PLOT 1, TOWNHOUSE FARM – REPLACEMENT DWELLING DRAINAGE – FOR PLANNING DOC

Drainage Information for Proposed Replacement Dwellings

Revision P3

24-080

Title
PROPOSED DRAINAGE LAYOUT

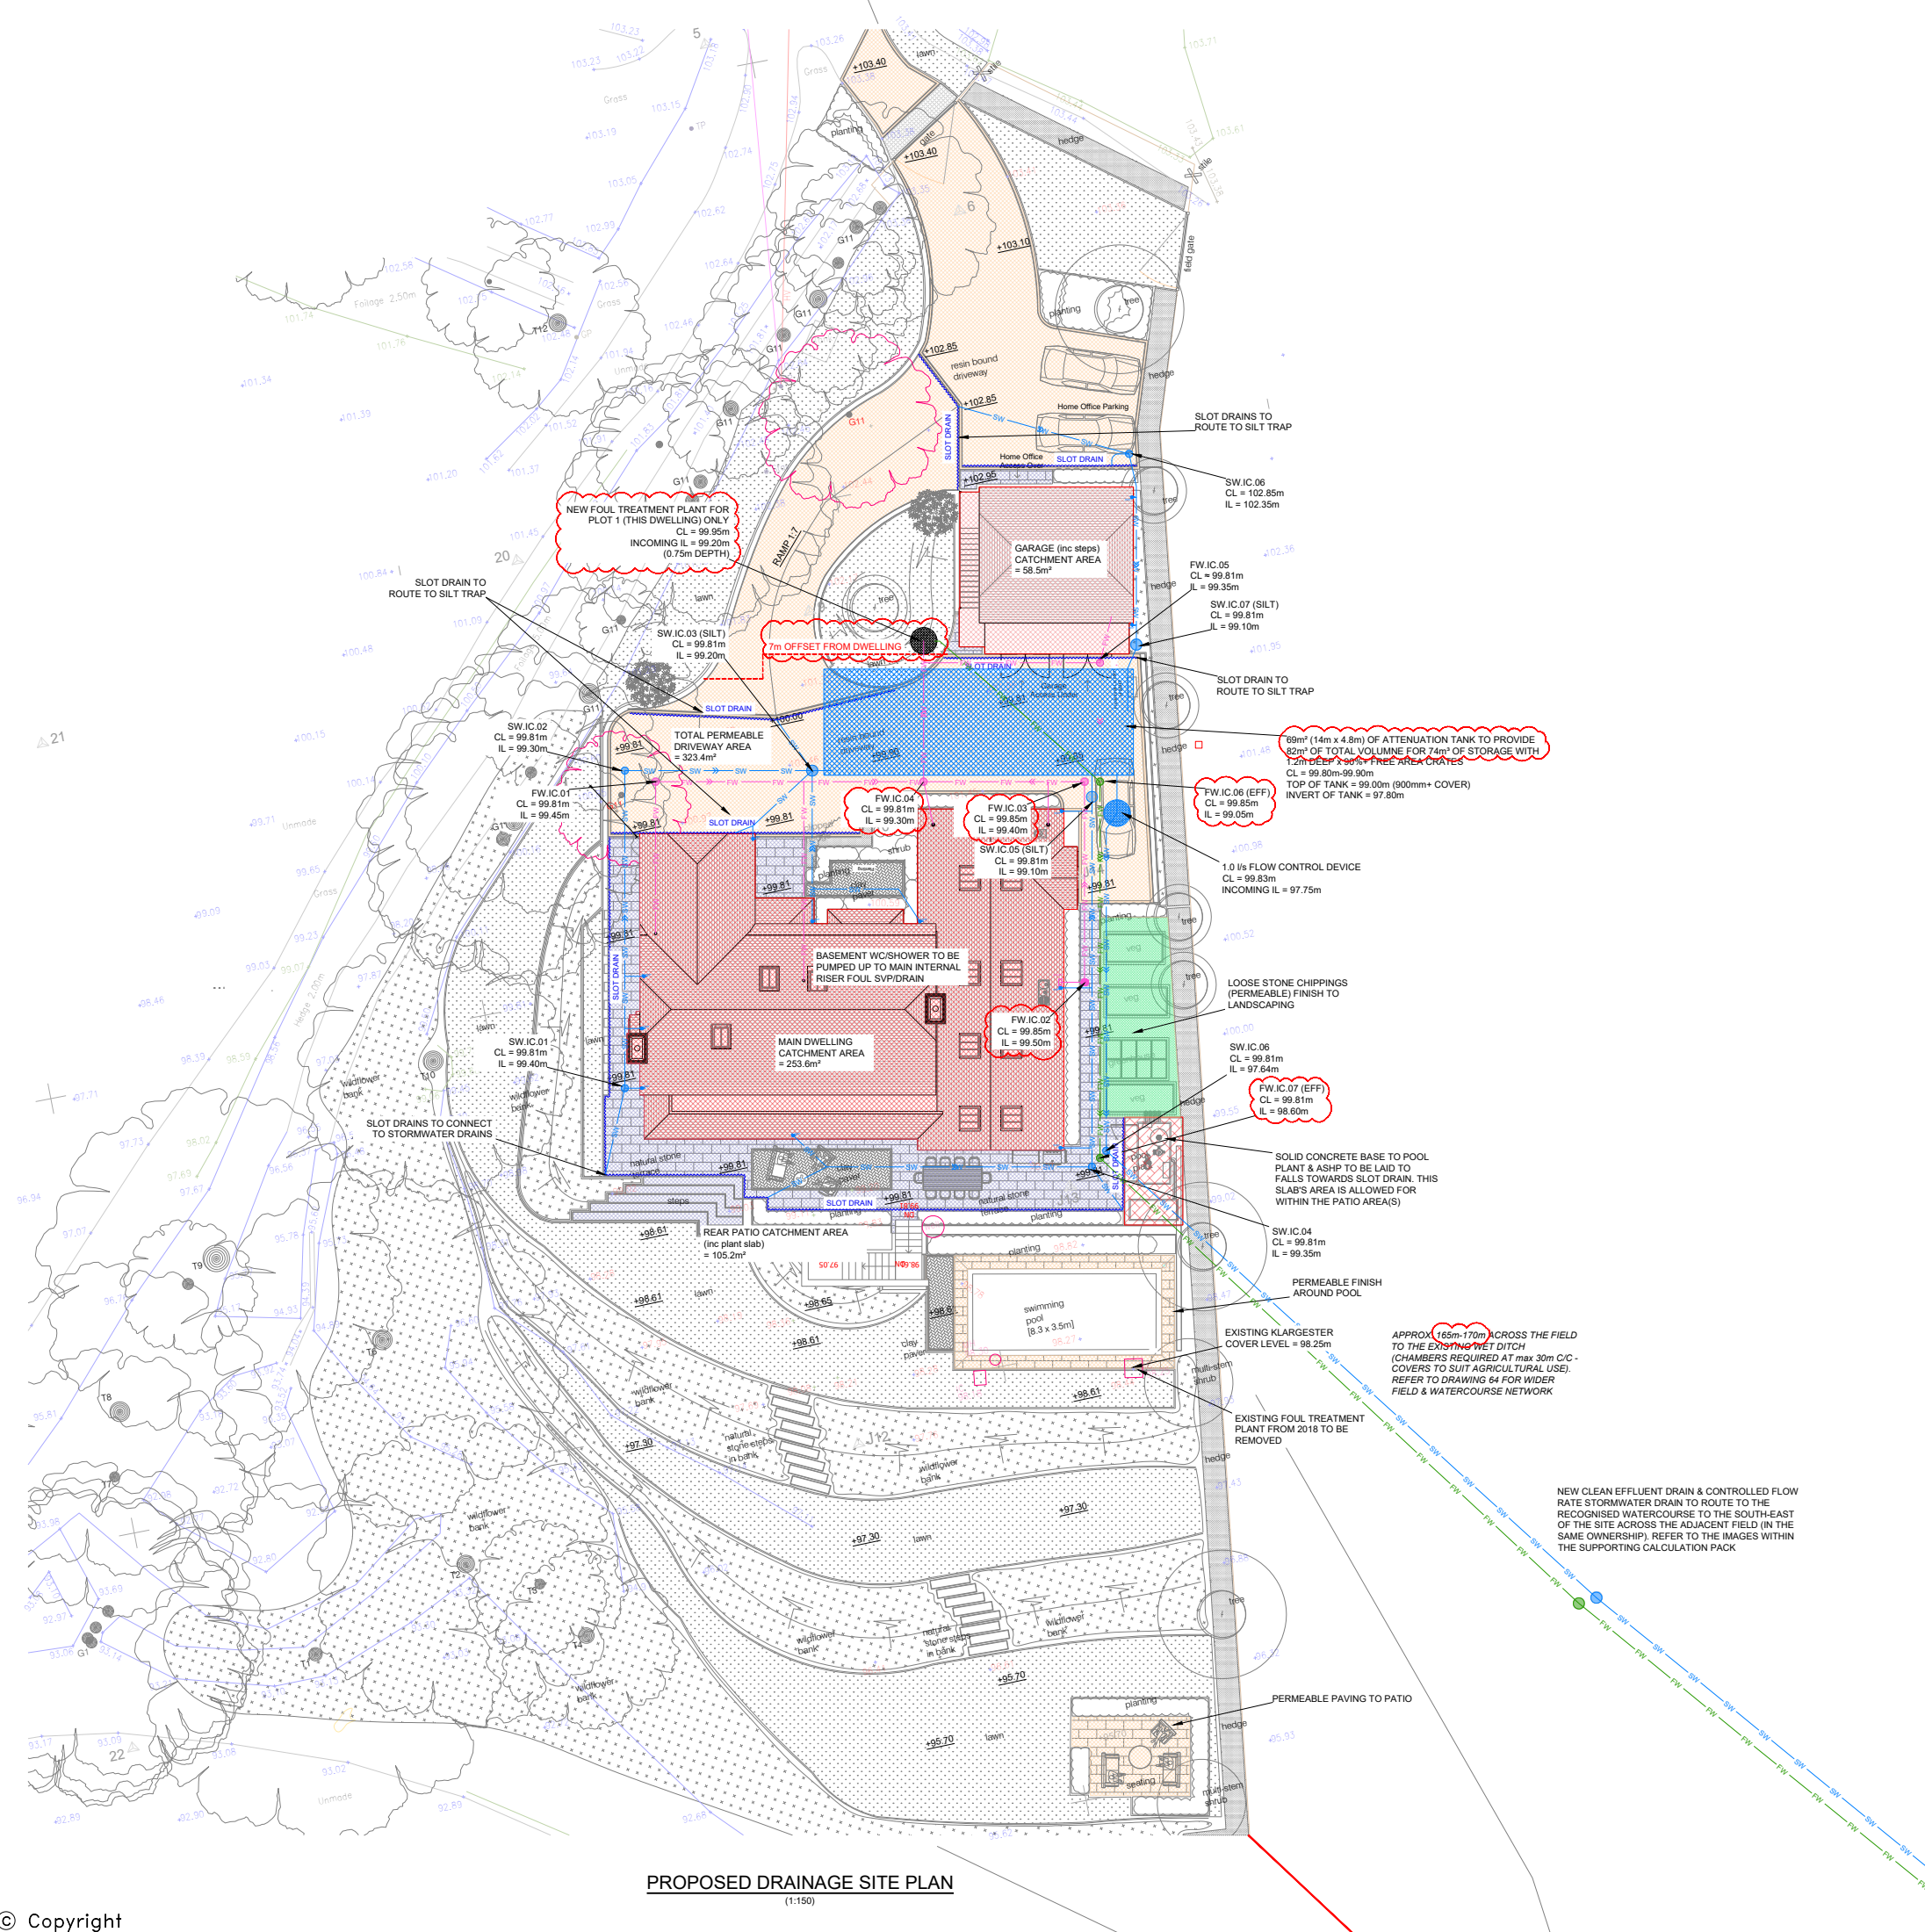
P2 – The discharge location is moved from the local ditch to the main recognised watercourse with the new foul treatment plant location moved to within 10m of the existing location and now 16m+ from the dwelling. There are no changes in catchment areas, calculations etc, just the location of the treatment plant, length of trenching & drains extended across the agricultural field and the final discharge location changed.

P3 – This revision covers the inclusion of site specific rainfall data, thus removing the ‘estimation’ concern. The rainfall data was purchased as a point data from the UK Centre for Ecology & Hydrology. This links in with the UKSuds design software. At the time of inputting the new area data in a different arrangement, it was noted that the catchment area was previously misrepresented. The correct positively drained area(s) are now included, which requires a larger volume. It is also noted that the UKSuds software only allows for 90% geocellular crates, whereas most standard crates are 95% free area, thus extra volume will be provided as the size has been provided based on the conservative 90% free area.

REV	DESCRIPTION	DATE	BY
P1	FOR PLANNING DOC ONLY	17.12.2024	PW
P2	NEW FOUL TREATMENT PLANT MOVED WITHIN 10m OF EXISTING WITH SURFACE WATER ROUTE TO FOLLOW FOUL ROUTE	30.06.2025	PW
P3	RELOCATED FOUL PLANT, ATTENUATION UPDATED TO SUIT RAINFALL DATA & CORRECTED AREA(S). NOTES ADDED FOR DRG 64	01.09.2025	PW

THE NEW FOUL DRAINAGE COMPRISES A NEW KLARGESTER LOCATED WITHIN THE FRONT LANDSCAPED AREA (7m AWAY FROM NEW DWELLING & ADJACENT TO PARKING AREA WITH A NEW DRAIN ROUTED ACROSS (BELOW) THE AGRICULTURAL FIELD WITH AN OUTFALL TO THE MAIN WATERCOURSE. THE NEW STORMWATER DRAINAGE PROPOSAL FOR THE DWELLING COMPRISES TYPICAL RWPS THAT ROUTE TO AN ATTENUATION TANK WITH CONTROLLED FLOW TO THE WET DITCH VIA DRAINS ROUTING ACROSS (BELOW) THE AGRICULTURAL FIELD. THE FLOWS ARE CONTROLLED TO 1.0 l/s. NOTE THAT THIS IS DIFFERENT TO THE EXISTING OUTFALL, WHICH DID NOT MEET EA BINDING RULE 19.

PROPOSED SIZE IS 14m LONG x 4.8m WIDE x 1.2m DEEP. THIS PROVIDES 82m³ OF STORAGE VOLUME WITH 90%+ FREE AREA CRATES.

Title
PROPOSED DRAINAGE LAYOUT
WIDER SITE PERSPECTIVE

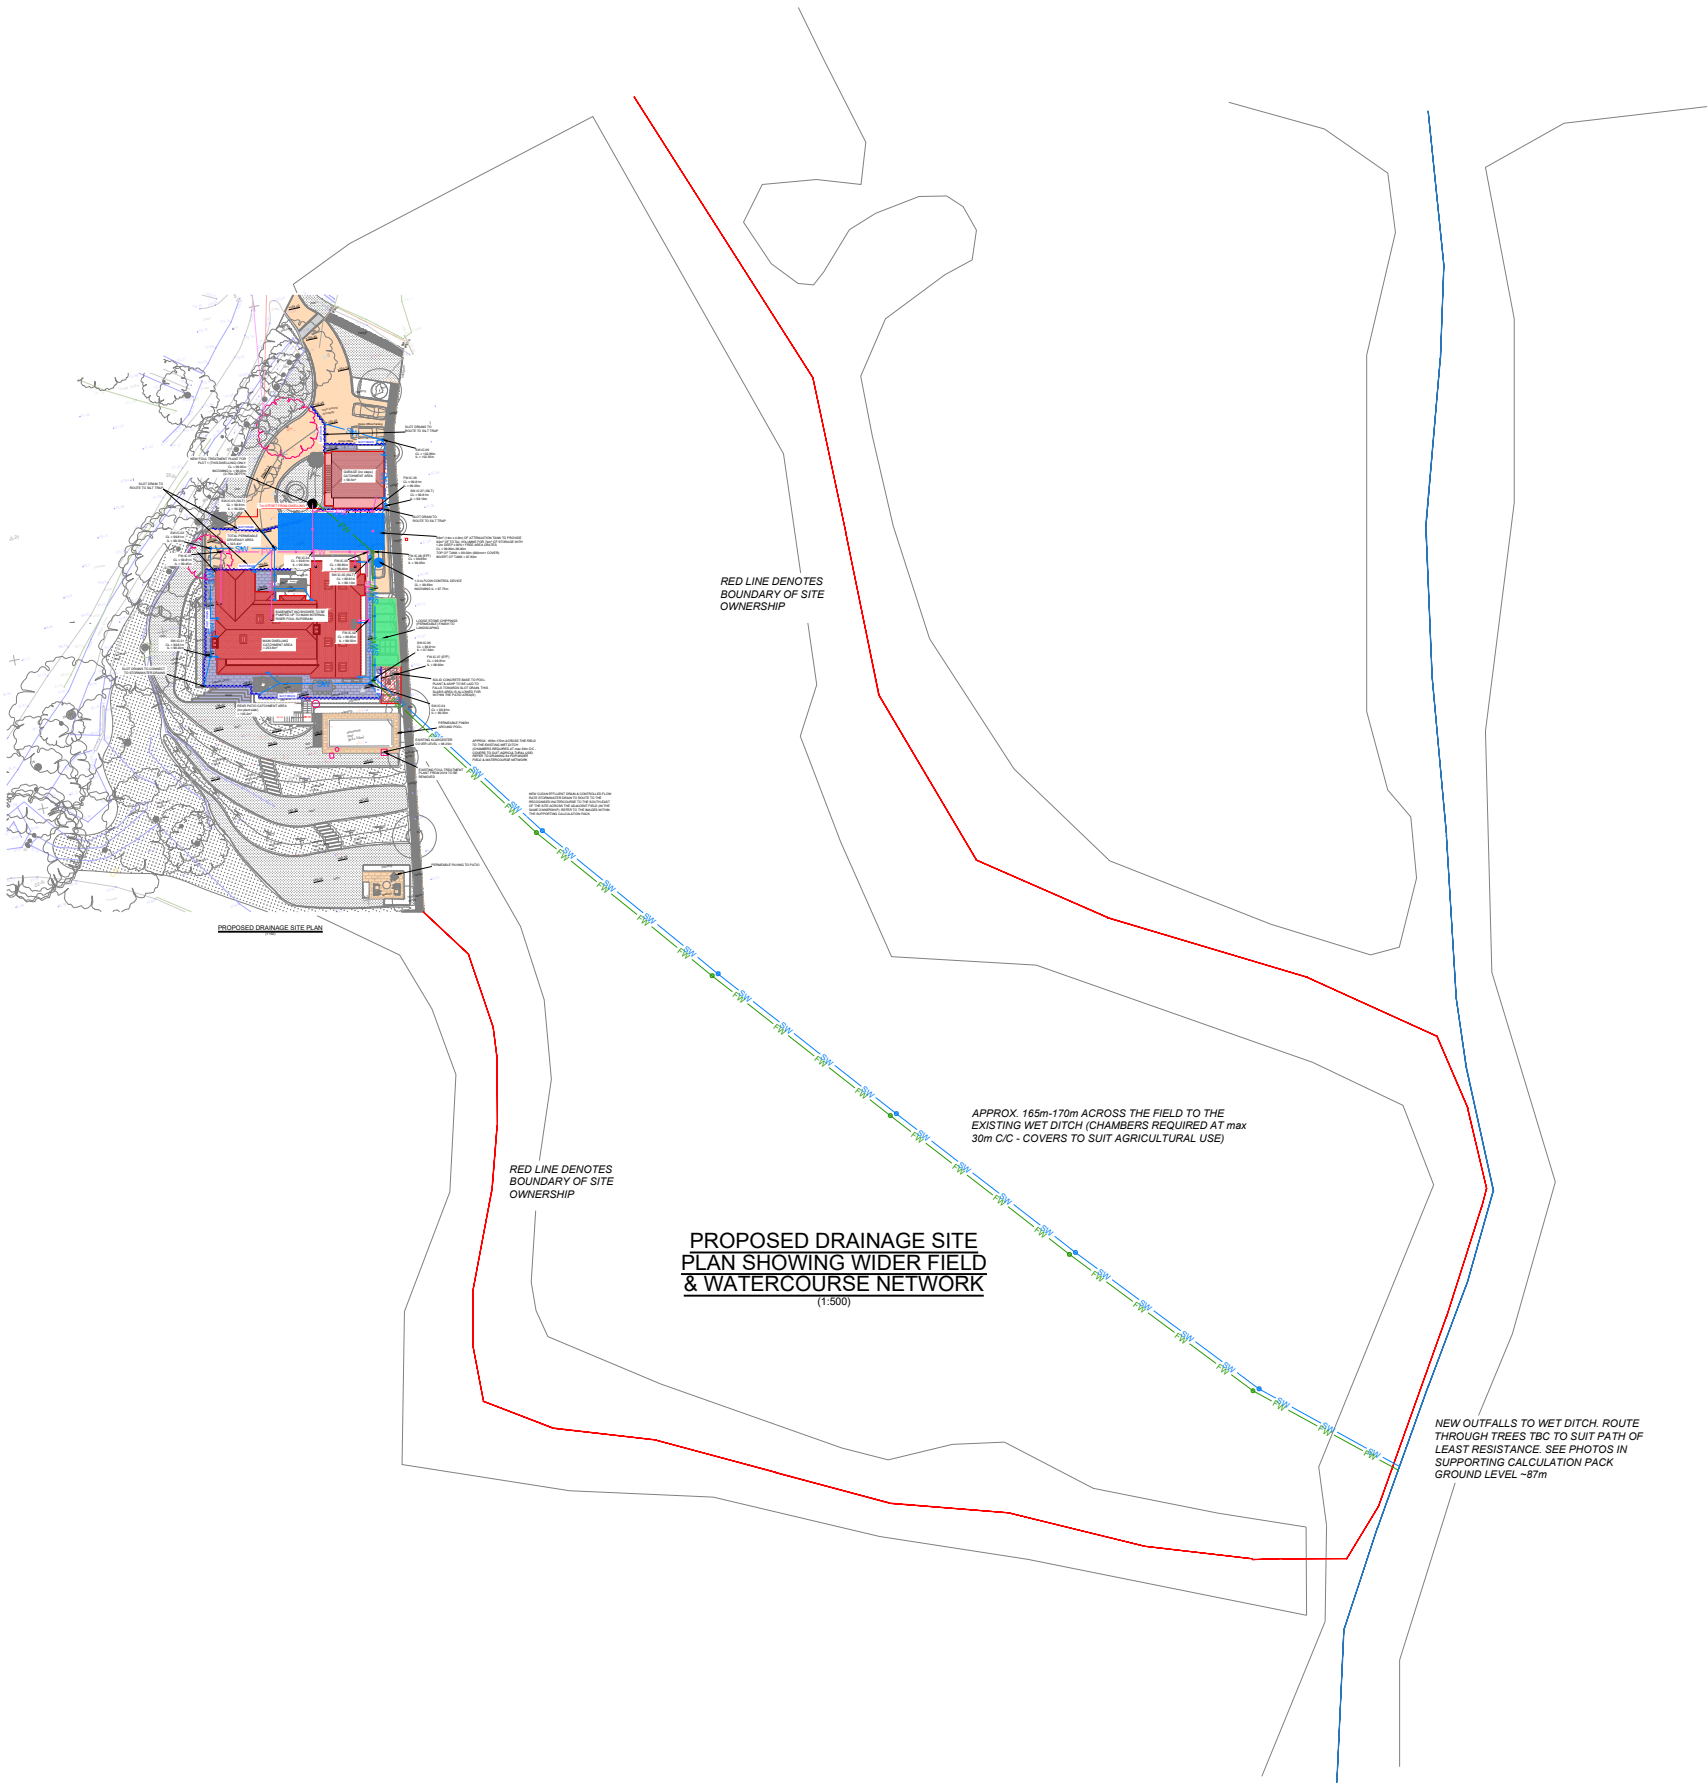
A new drains (64) has also been created, which shows the full route across the adjoining field. This also confirms the location of the chambers and flow control chambers in the field adjacent to the proposed dwelling are within the boundary of ownership.
